Response to EPA Information Request for C3 Petrochemicals LLC
Propane Dehydrogenation Plant - Chocolate Bayou Plant
Application for Greenhouse Gas Prevention of Significant Deterioration Permit

C3 Petrochemicals LLC – PDH Plant
Process Flow Diagram Sheet 4,
Reactors and Heaters Train 2 Details

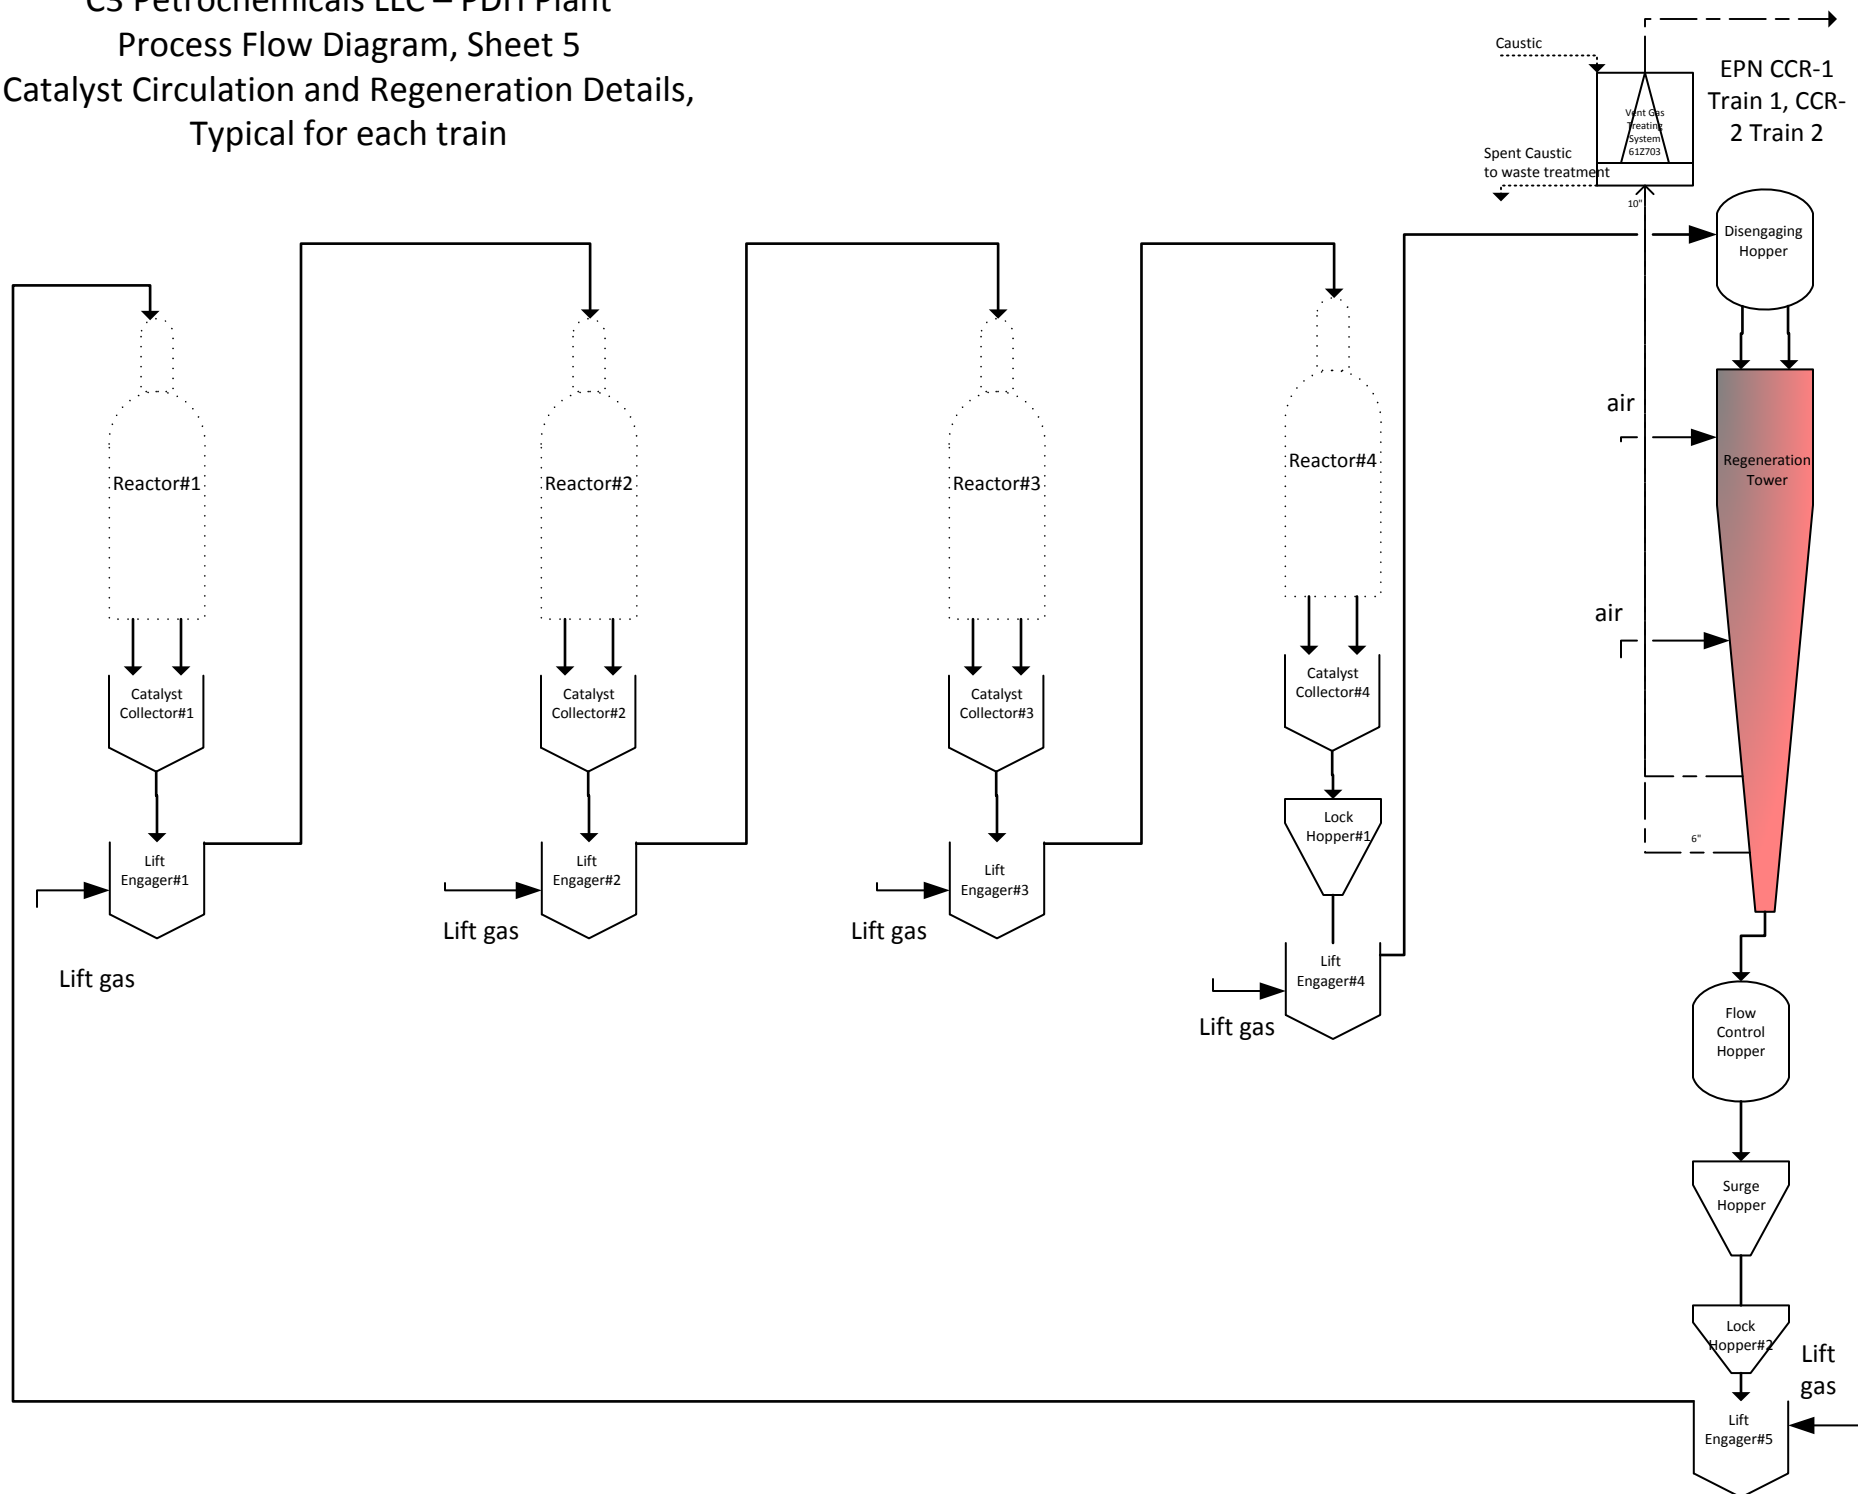
- A. A representation of the two trains with four reactors in series along with the emission point identification numbers. Please include the charge heaters that are prior to the first reactors in series and the inter-heaters that are prior to the second, third and fourth reactors in series. On page 21 of the application, it is stated that ultra-low NO_x burners and selective catalytic reduction (SCR) will be used on the charge heaters and the three inter-heaters on each reactor train. Please show the SCR add-on pollution control device to be used on the heater.

C3P RESPONSE: A revised overall process flow diagram for the PDH process is included as Sheet 1 of the attachments. More detailed process flow diagrams for each reactor train are also attached. Sheet 3 provides the requested detail for reactors and heaters in Train 1. Sheet 4 provides this detail for the reactors and heaters in Train 2.

C3 Petrochemicals LLC – PDH Plant
Process Flow Diagram, Sheet 5
Catalyst Circulation and Regeneration Details,
Typical for each train

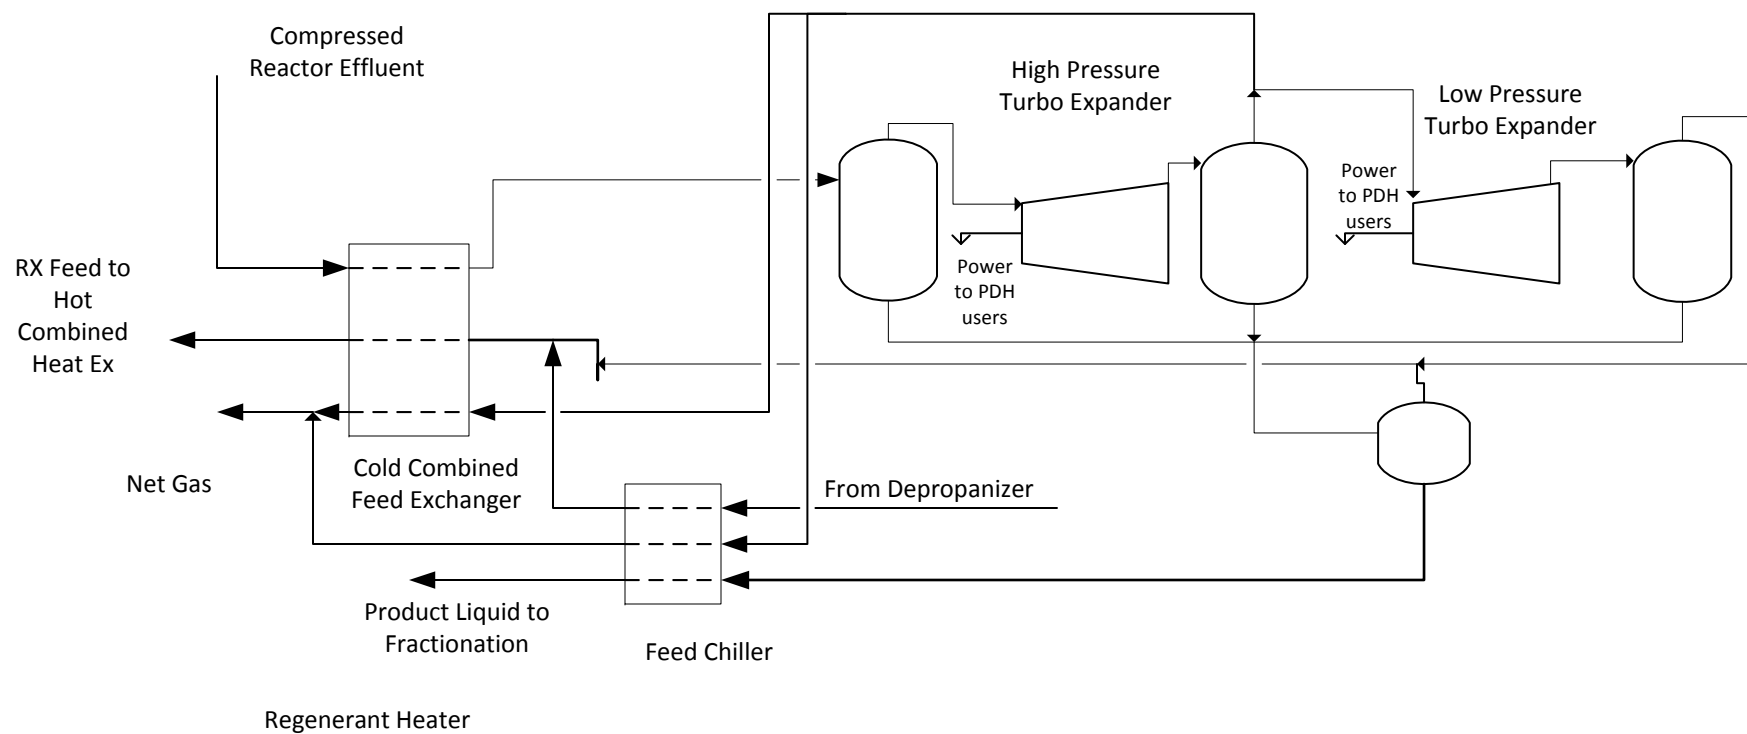
- H. Continuing on page 21 of the permit application, after the catalyst leaves the regeneration towers, it flows by gravity into a hopper where the nitrogen and oxygen atmosphere from the regeneration towers are purged from the catalyst and the atmosphere is changed to hydrogen. The catalyst then flows from the hopper to a lift engager, where high purity hydrogen is used to pneumatically lift the catalyst back to the top of reactor no. 1. It is unclear from the process description if the catalyst will only be used in reactor no. 1 in each train or in all four of the reactors in the train. The process description shows feed lines directed to and from reactor train 1 and 2. Please clarify.

C3P RESPONSE: The catalyst circulation and regeneration drawing (Sheet 5 of the attached process flow diagrams) shows the details of catalyst flow and regeneration. Each reactor train, consisting of 4 reactors operated in series, will have a dedicated regeneration tower. Catalyst regeneration is a continuous process. Catalyst is lifted with hydrogen from the bottom of the regeneration tower to the top of reactor 1. It flows by gravity down reactor 1 and is then lifted with process gas to reactor 2. Catalyst flows by gravity down reactor 2 and is lifted by process gas to reactor 3, where gravity flow leads to a lift with process gas to reactor 4. Catalyst is finally lifted to the regeneration tower after reactor 4. The entire cycle for catalyst takes approximately 1 week as the catalyst progresses through reactors 1-4 and ultimately to the regeneration tower.

C3 Petrochemicals LLC – PDH Plant
Process Flow Diagram, Sheet 7
Storage, Truck Loading, and Flare

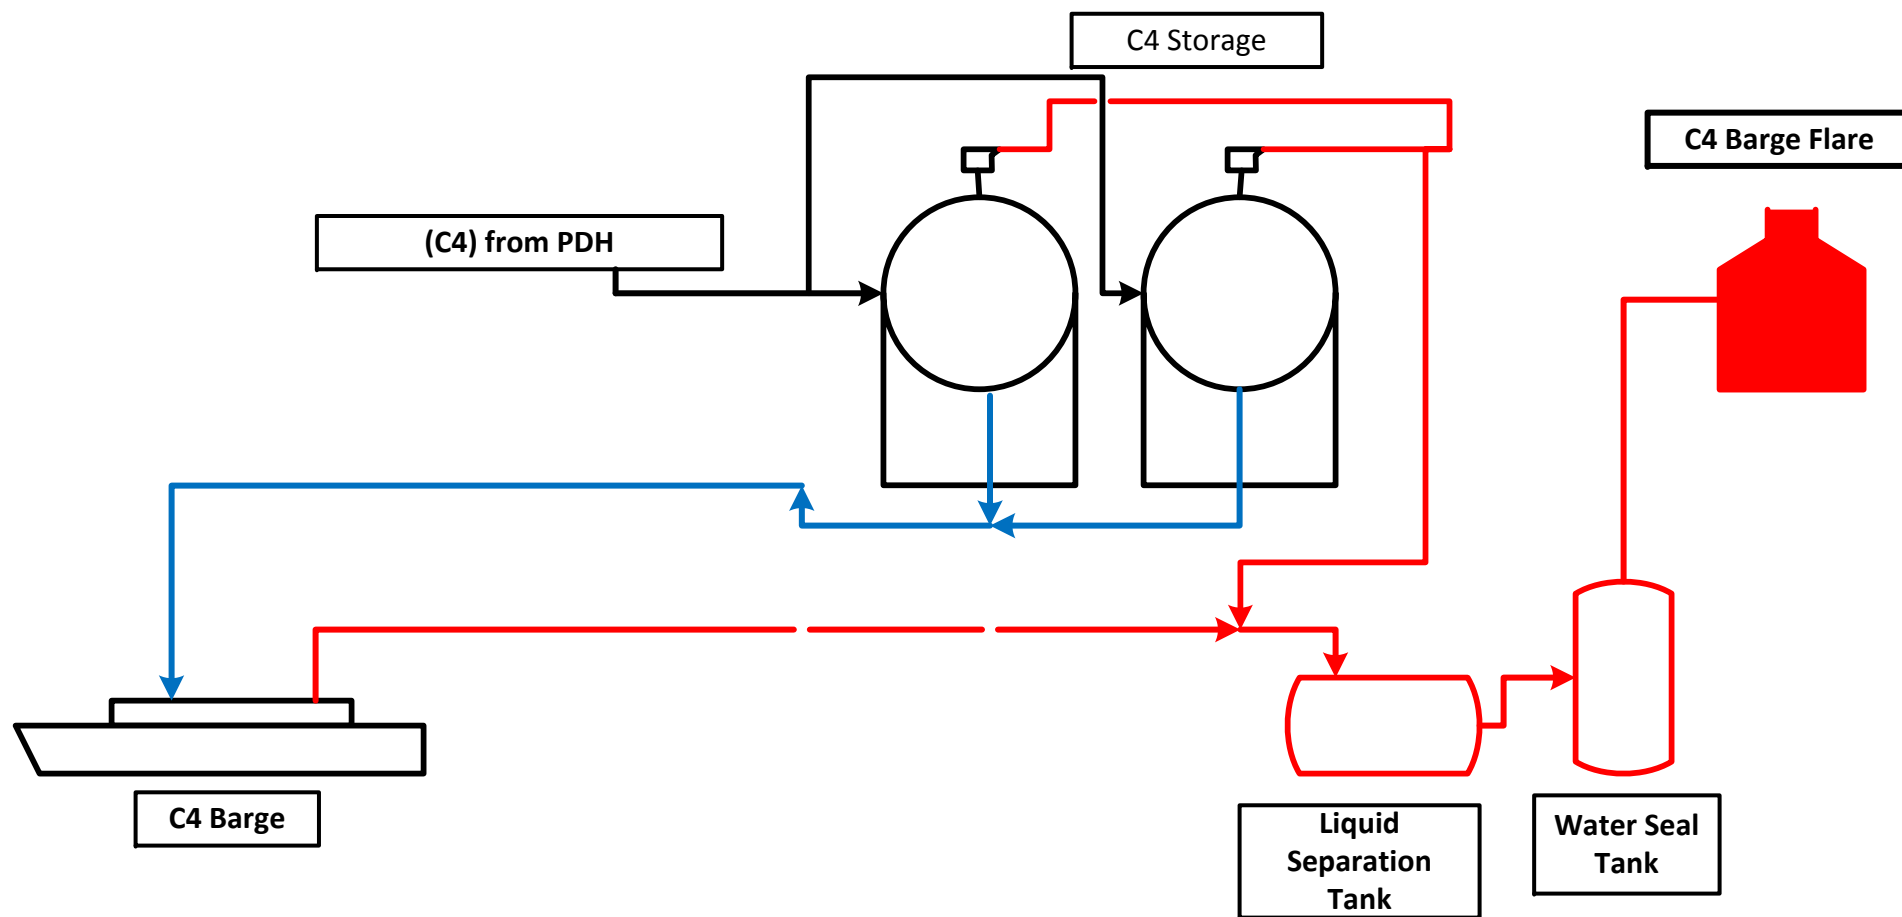
- F. On page 21 of the permit application, it states that C5+ liquids are loaded into tank trucks. Also, on page 23 of the application it is stated that VOCs used in the process are received via tank truck and emissions are controlled by the PDH flare. Is this truck loading and unloading system new, modified, or affected (existing non-modified)? Will the vents from the operation of the system increase to the project? Please update the process flow diagram to show the truck loading and unloading system and vents directed to the flare.

- ii. If possible, please include a separate process flow diagram to depict the flare header and all the vessels that will have vents directed to the flare. Also, please include tank storage (e.g., aromatics that are used in the process, C5+ liquids storage tanks, ammonia storage, and product storage).

C3P RESPONSE: All truck loading and unloading at the proposed PDH plant will be new systems. Sheet 7 of the process flow diagrams shows the truck loading, truck unloading, and vents directed to the flare.

C3P RESPONSE: Sheet 7 of the process flow diagrams shows product storage and the ground flare. Sheet 8 shows C4 storage and the Ascend barge loading flare.

C3 Petrochemicals LLC – PDH Plant
Process Flow Diagram, Sheet 9
Boilers

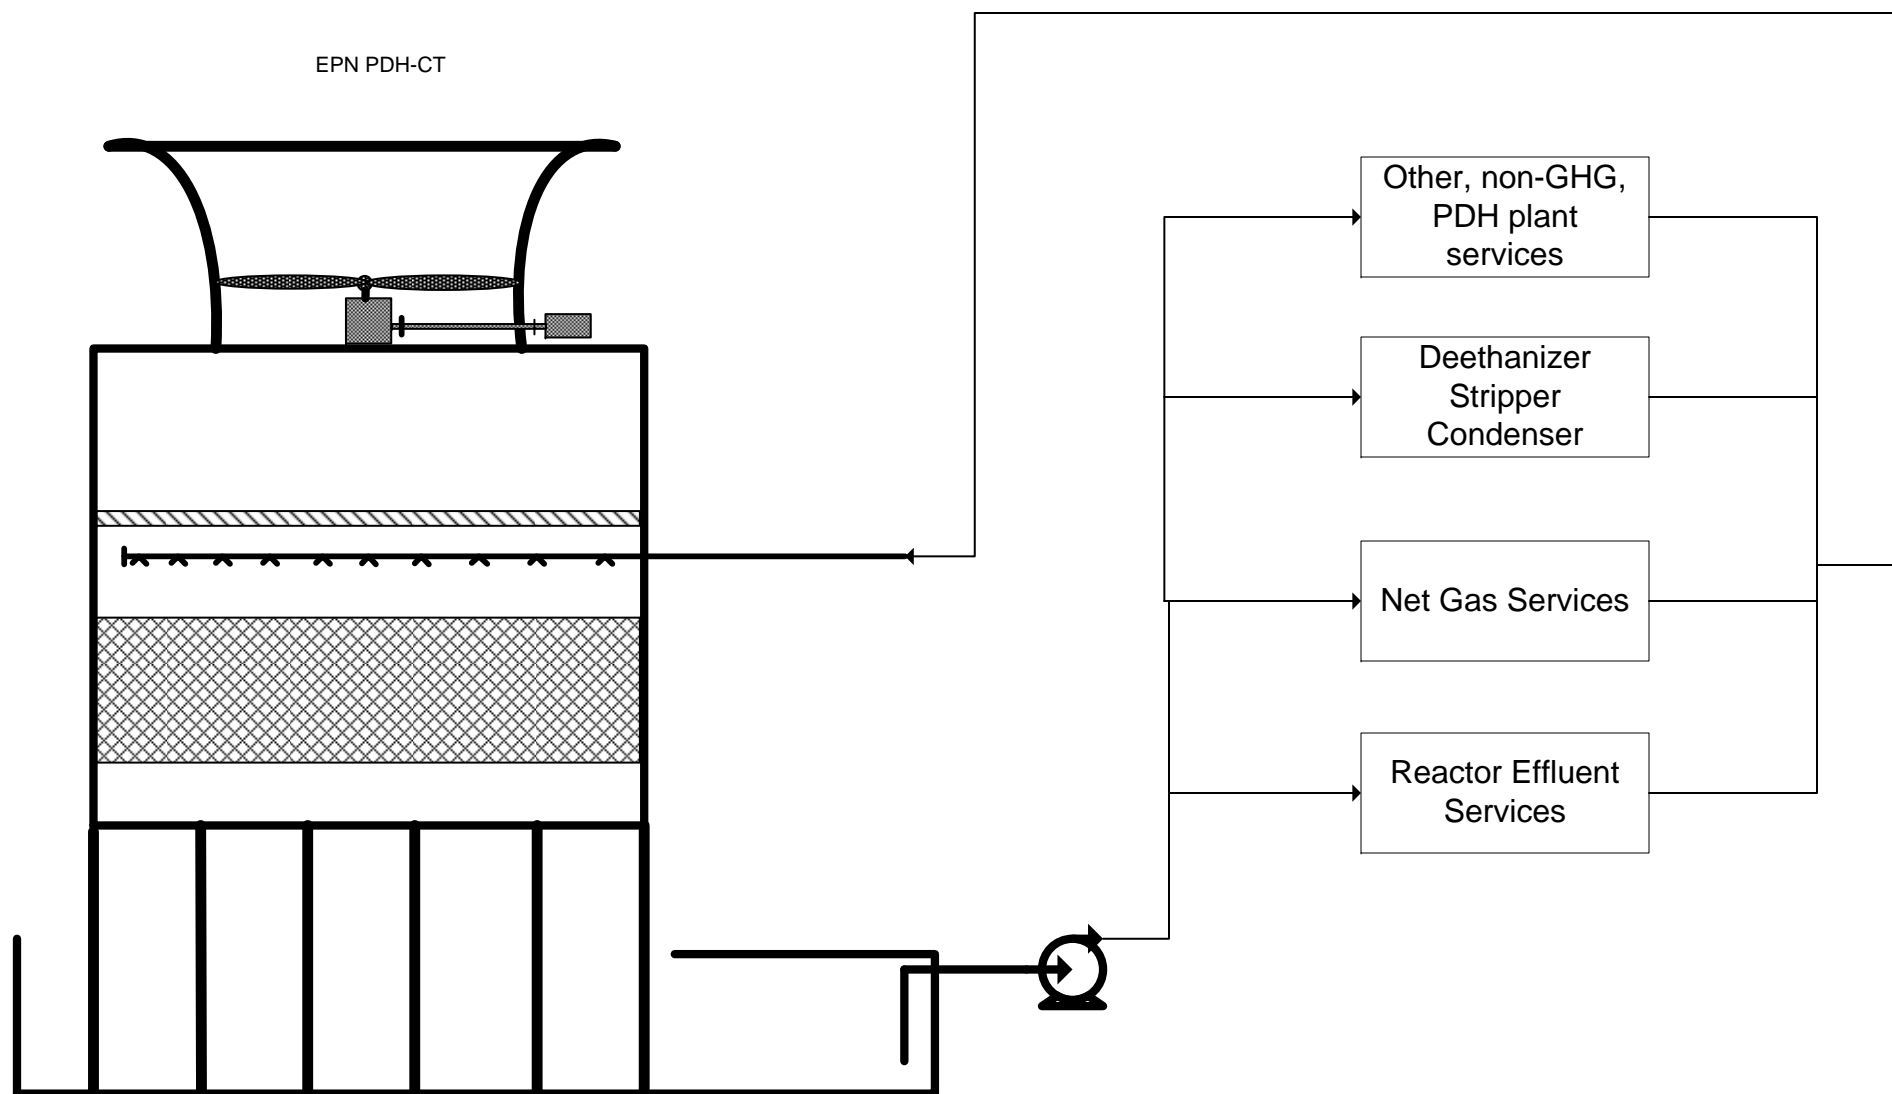
- N. On page 24 of the application, the process description states that two boilers will be used for steam generation to produce high pressure. The fuel that will be utilized will come from the fuel gas system. The boilers will utilize ultra-low NO_x burners and SCR. Both boilers will vent through a single stack and SCR unit. Please update the process flow diagram to show these two boilers with the common emission stack.

C3P RESPONSE: Sheet 9 of the process flow diagrams shows the configuration of the boilers, SCR, and stack.
